Percolation Test Report; 12010 Simpson Road
Tax Map 41, Parcel 333

The following comments pertain to the review of the OSDS Plan for 12010 Simpson Road.

SEWAGE DISPOSAL SYSTEM SPECIFICATIONS WORKSHEET

The following comments pertain to the review of the perc cert plan for 12010 Simpson Road:

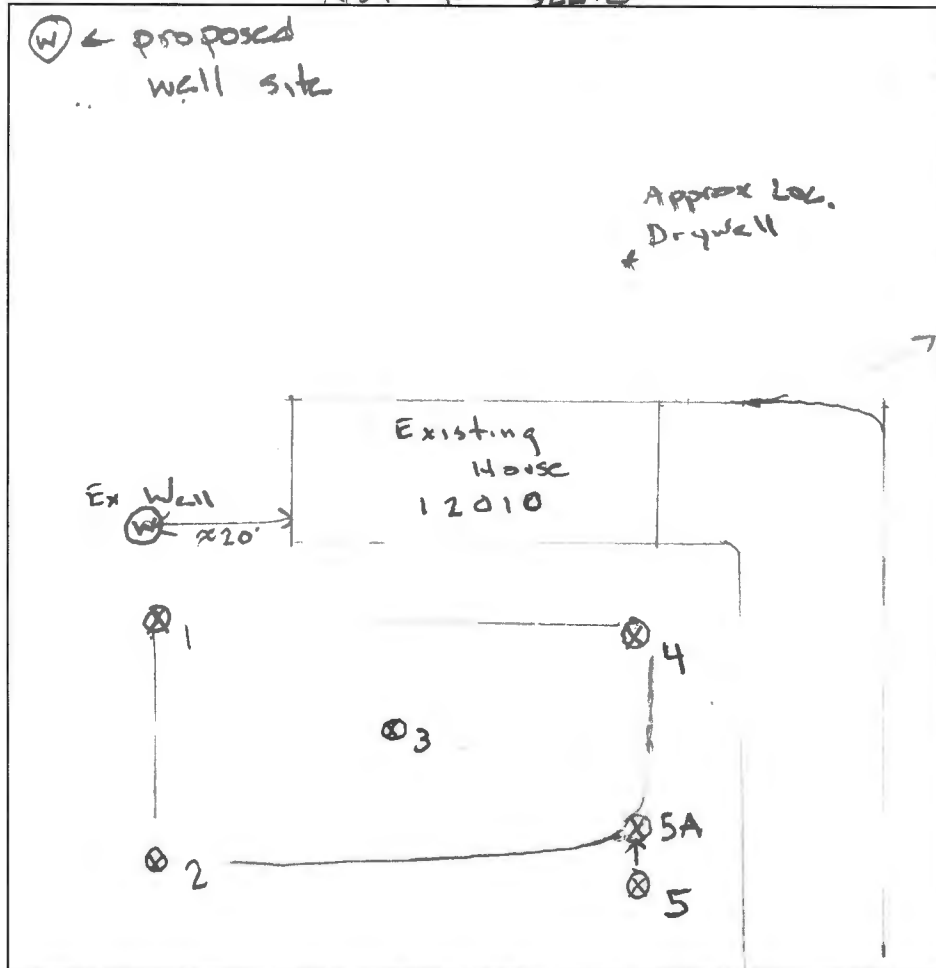
REMARKS Keep systems off hok 5; no sidewall
 SANITARIAN H. Oswald BACKHOE WTC OTHERS Eng / BU / owner
 TEST HOLES USED IN SDA _____ AVG. PERC TIME _____ SQ. FT/BR _____
 TRENCH WIDTH _____ INLET DEPTH _____ MAX. BOT DEPTH _____ EFFECTIVE SW _____

* Large mature trees within SDA.
 * Foggs located dry well, but not septic tank
